**POTENTIAL EXPLORATION, DEVELOPMENT, AND PRODUCTION OF
OIL AND GAS RESOURCES; VANDENBERG AIR FORCE BASE, CALIFORNIA**

FINAL ENVIRONMENTAL IMPACT STATEMENT

The final EIS relies upon the analyses provided in the draft EIS. It does not repeat draft EIS information. It provides erratas for the EIS, Air Quality Technical Appendix, and MRMP. In addition, public and written comments on the draft EIS and responses are provided.

Figure 5-1
PHYSIOGRAPHIC FEATURES
MRMP-2

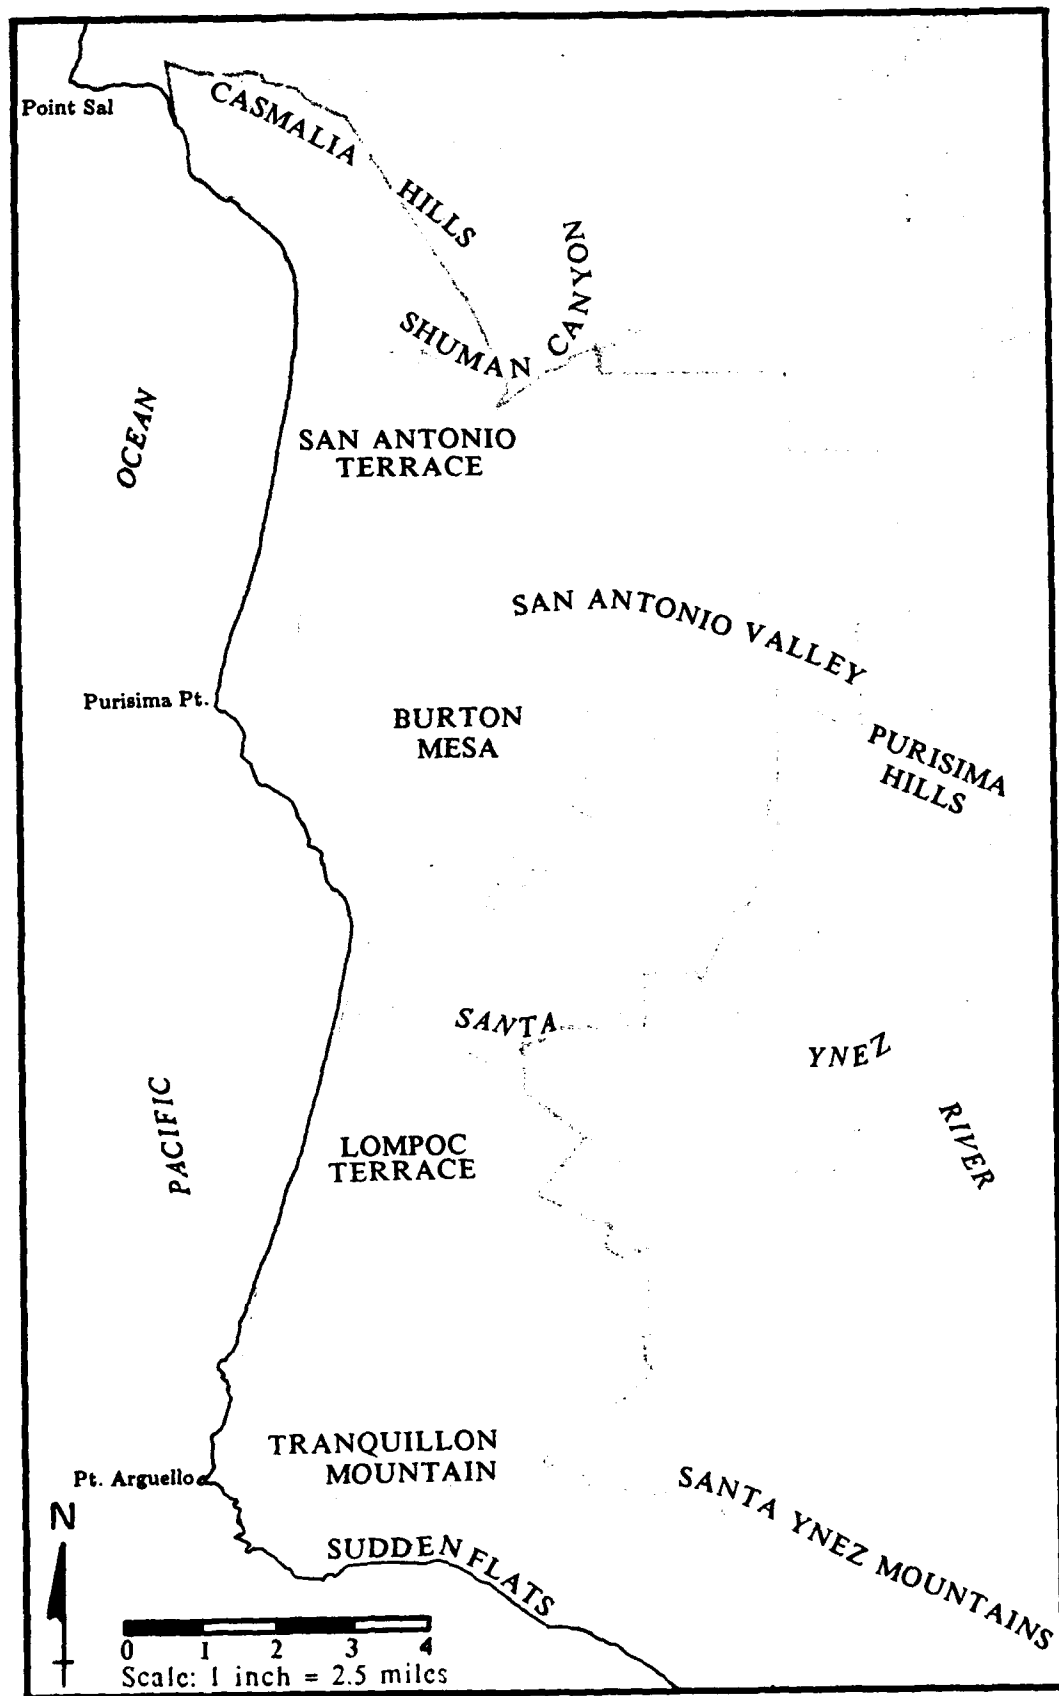
Figure 5-1 - Point Conception is incorrectly located

Figure 5-1 on page 5-2 has been revised. The words "Point Conception" no longer appear (see the attached figure).

Figure 6.5-3
INITIAL COMPLIANCE ACTIVITIES

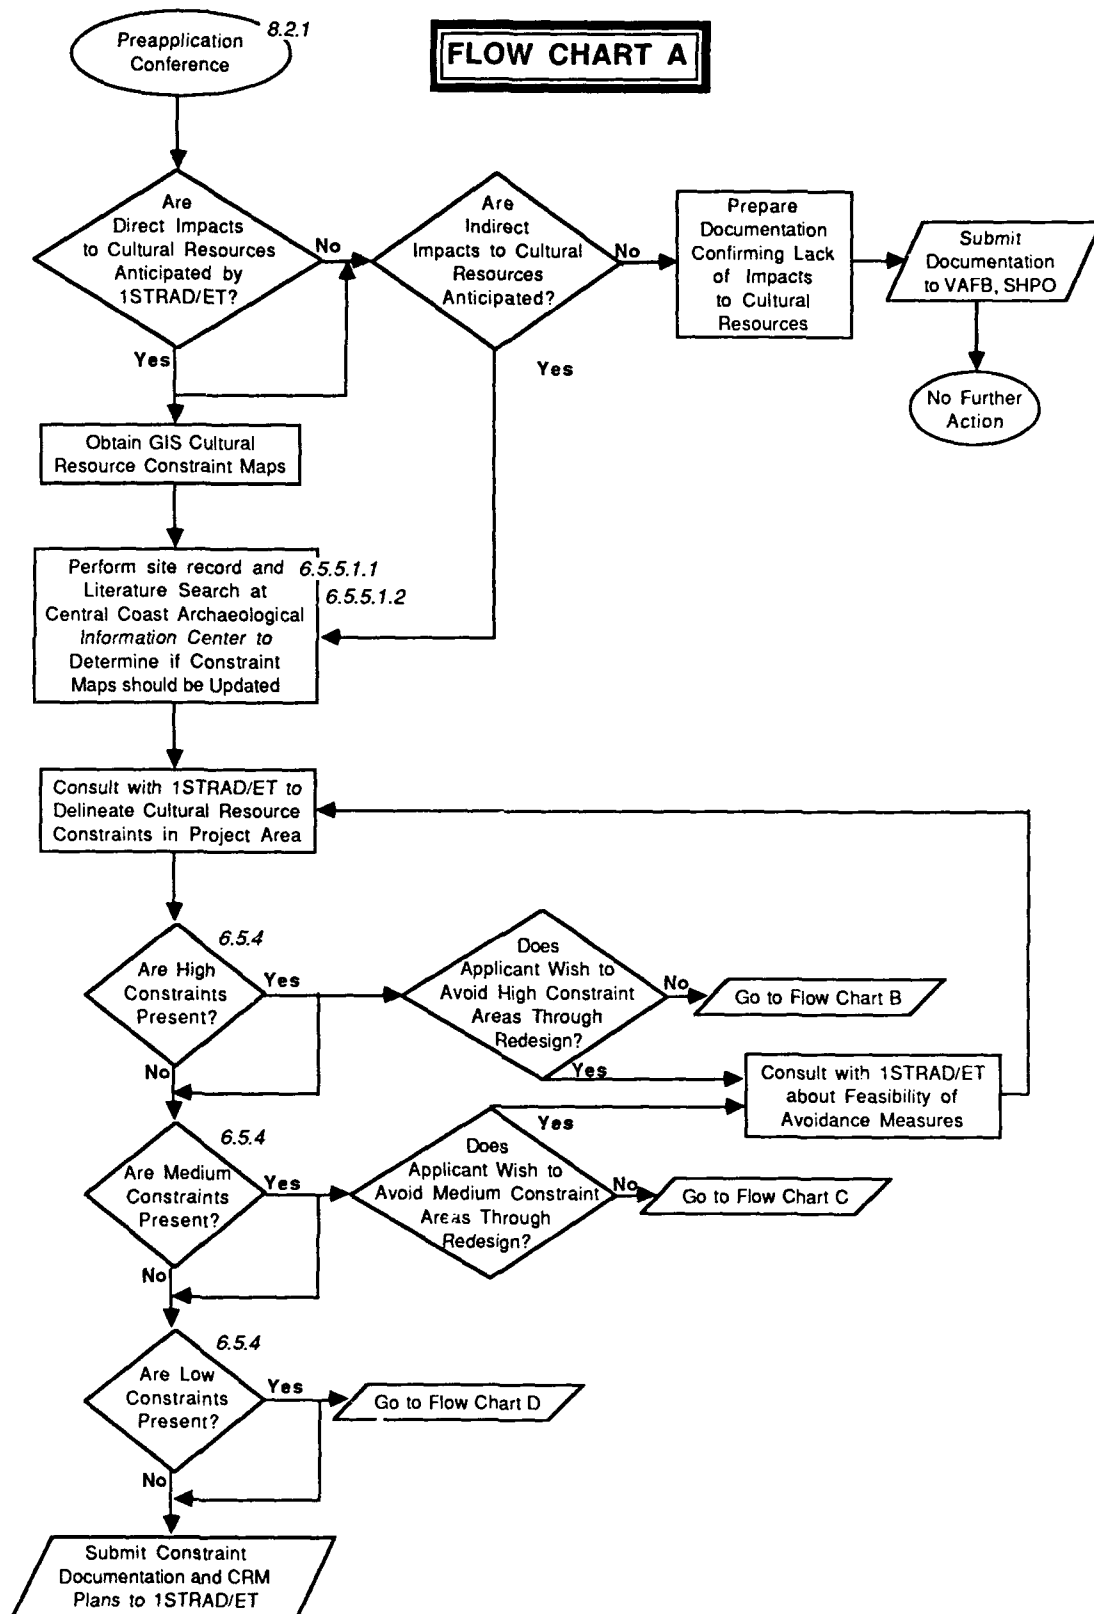
investigations. Project applicants should consult closely with the U.S. Air Force so that project redesign can be initiated as early as possible. Figure 6.5-3 (Flow Chart A) of the MRMP has been modified to show that avoidance can be implemented after the preapplication conference between the U.S. Air Force and project applicant and before boundary definition is necessary. In this way, an efficient process would be assured. Please see the MRMP errata for section 6.5, Cultural Resources.

Page 6.5-22, Figure 6.5-3 is replaced with the attached.

Figure 6.5-4

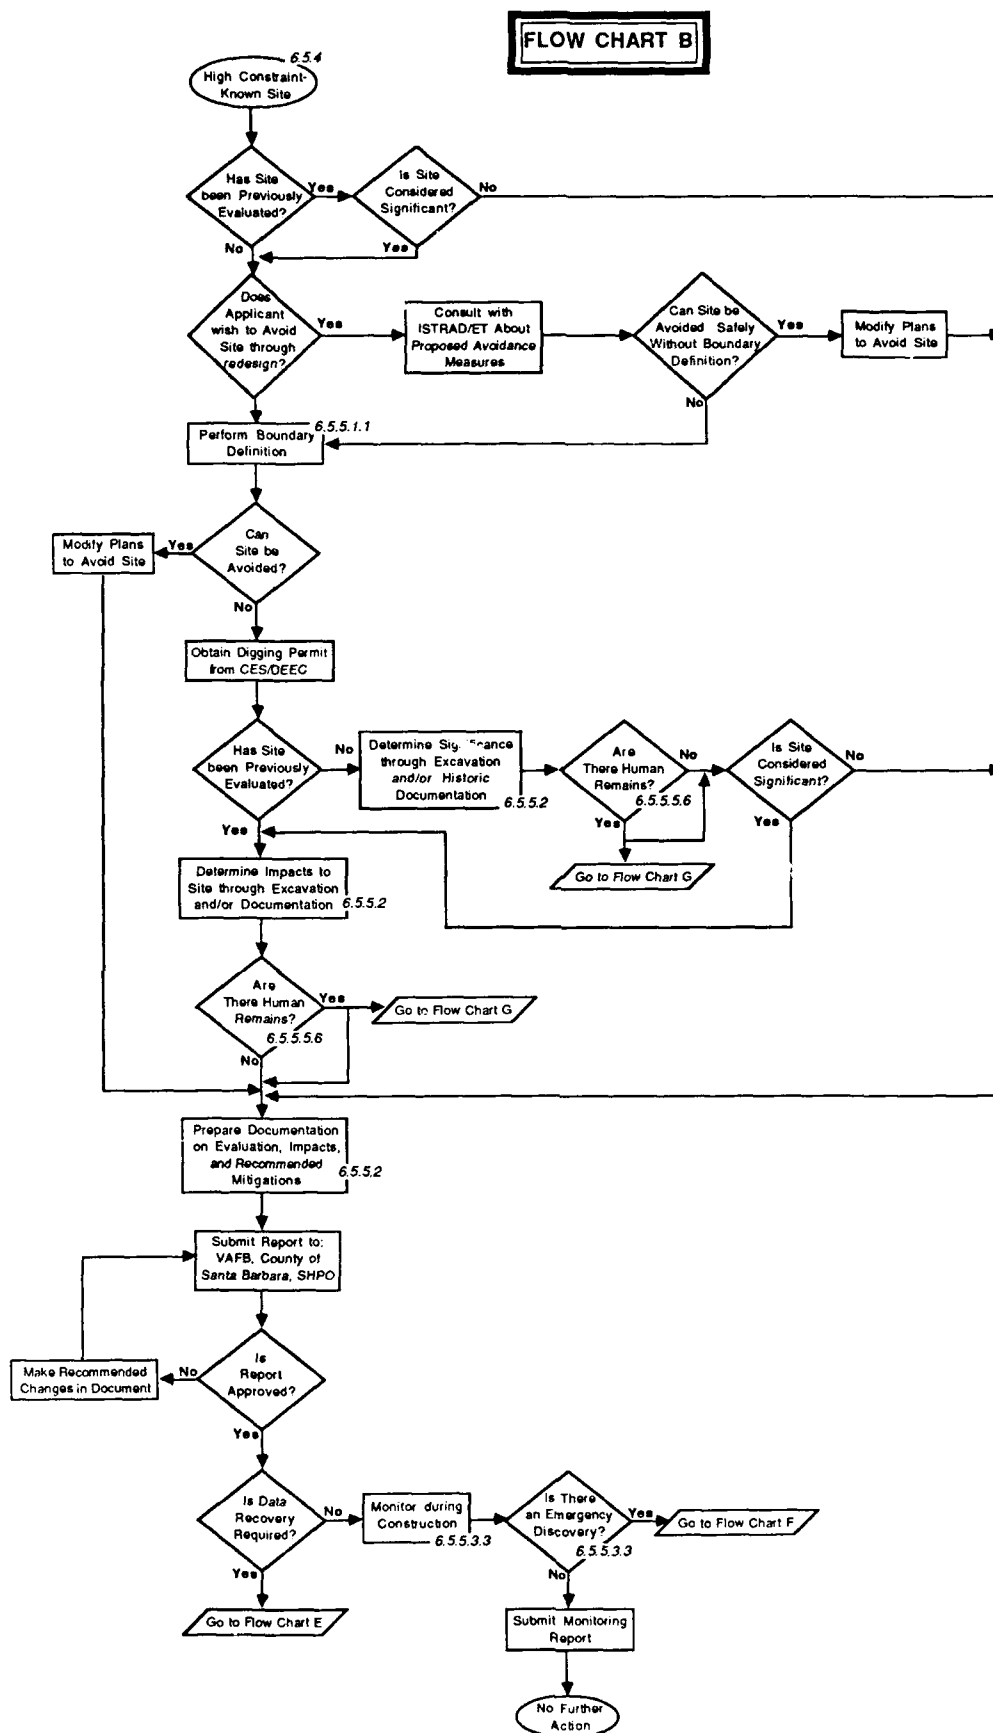
Union-41 The MRMP policies and guidelines are in complete agreement with this comment, and flow charts B, C, and D (Figures 6.5-23, 6.5-24, and 6.5-25) have been modified to show more clearly that project redesign may be implemented prior to the performance of subsurface survey. Please see the MRMP errata for section 6.5, Cultural Resources.

Page 6.5-23, Figure 6.5-4 is replaced with the attached.

Figure 6.5-5
COMPLIANCE ACTIVITIES IN MEDIUM CONSTRAINT AREAS

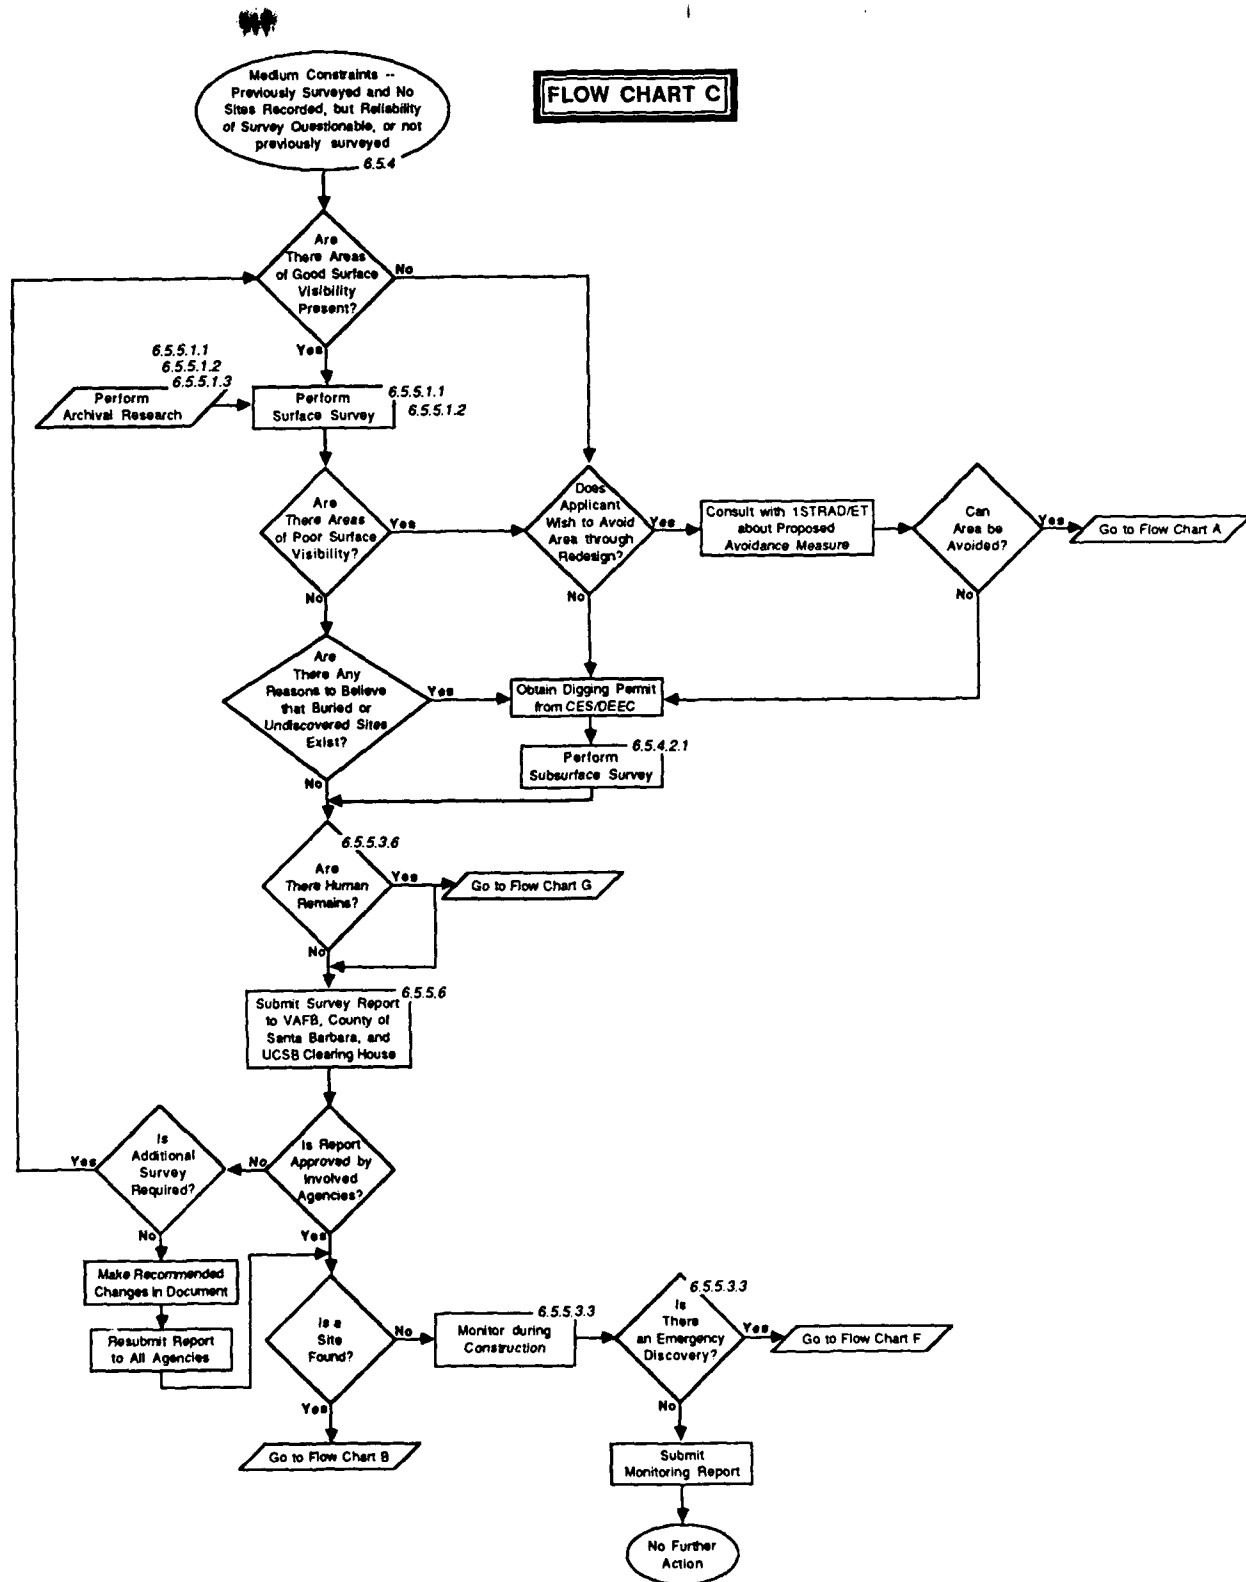
Page 6.5-24, Figure 6.5-5 is replaced with the attached.

Figure 6.5-6
COMPLIANCE ACTIVITIES IN LOW CONSTRAINT AREAS

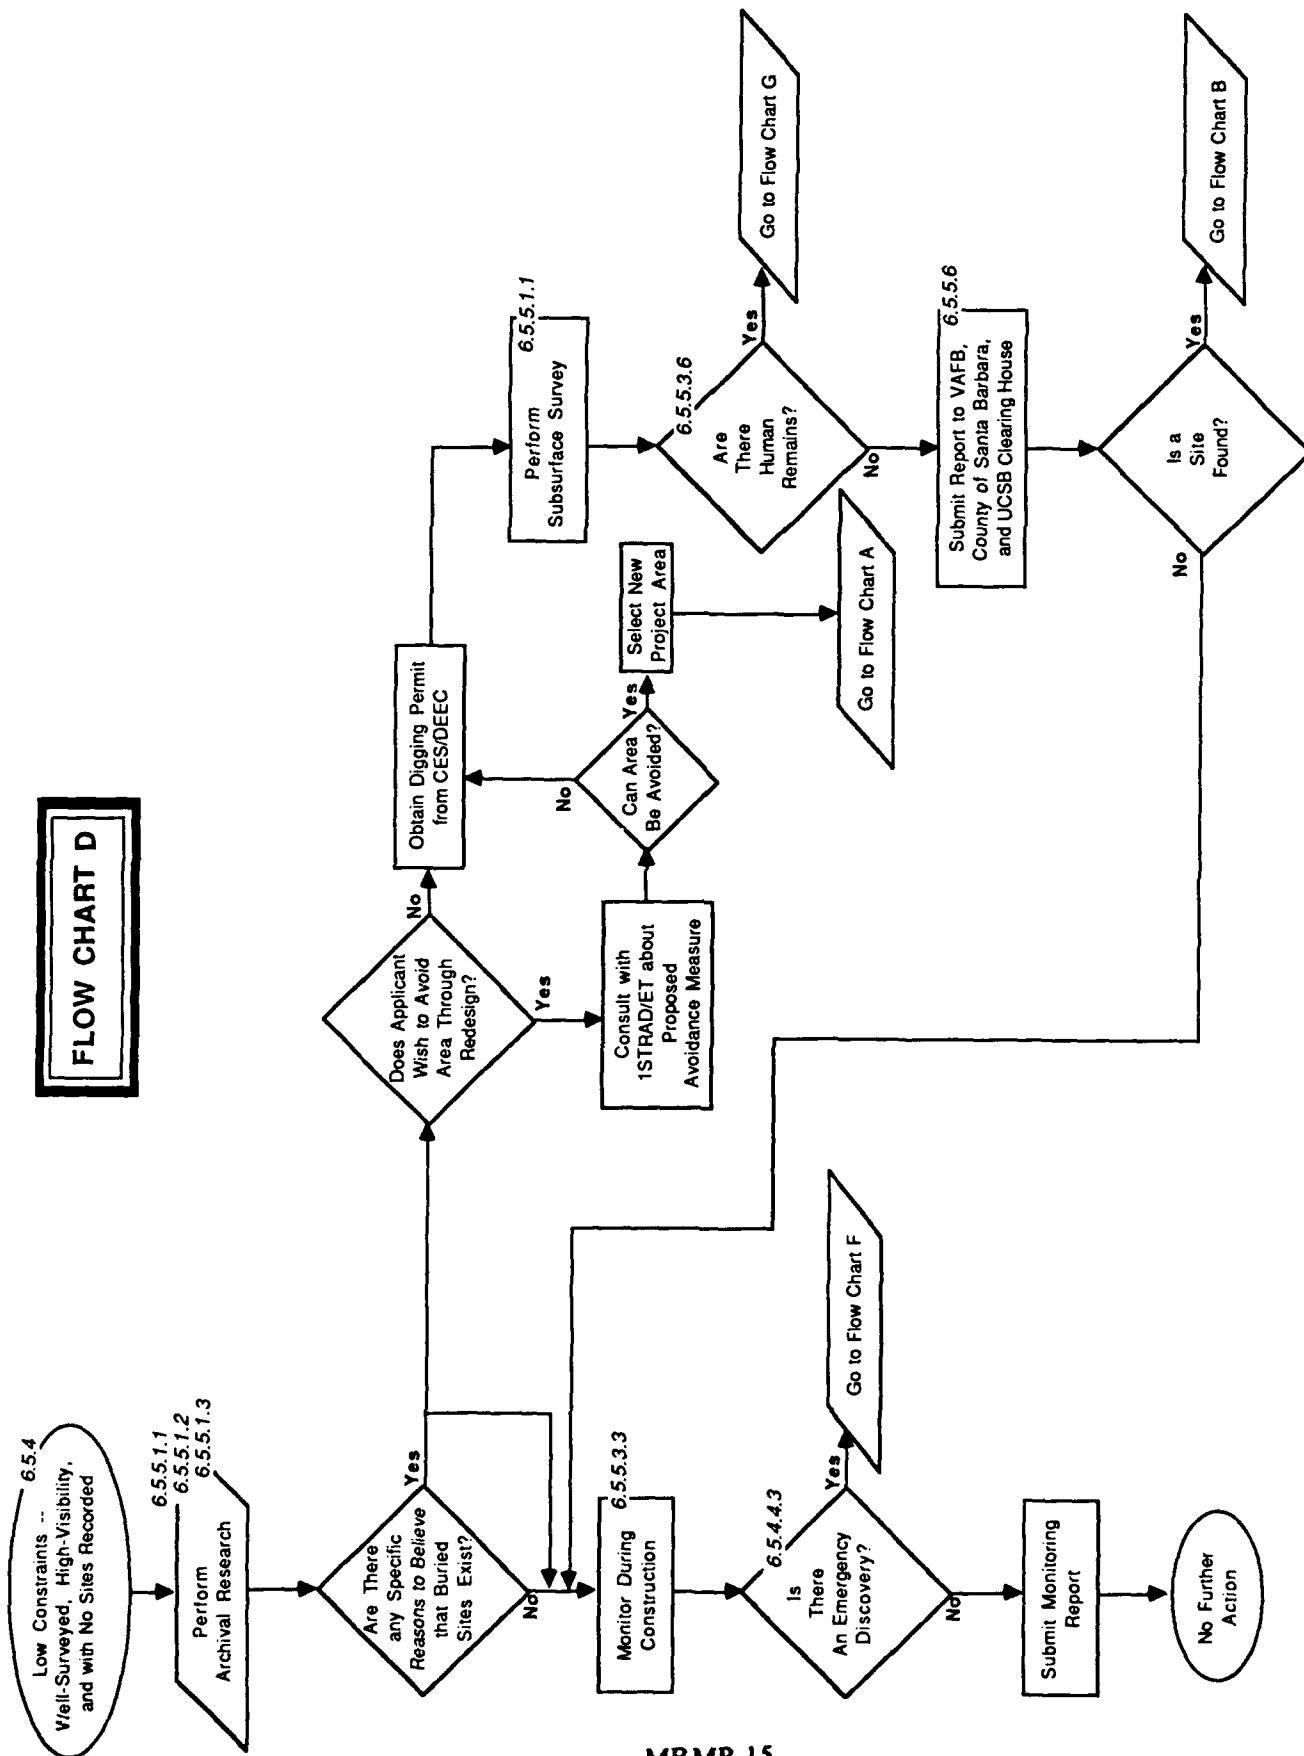
Page 6.5-25, Figure 6.5-6 is replaced with the attached.
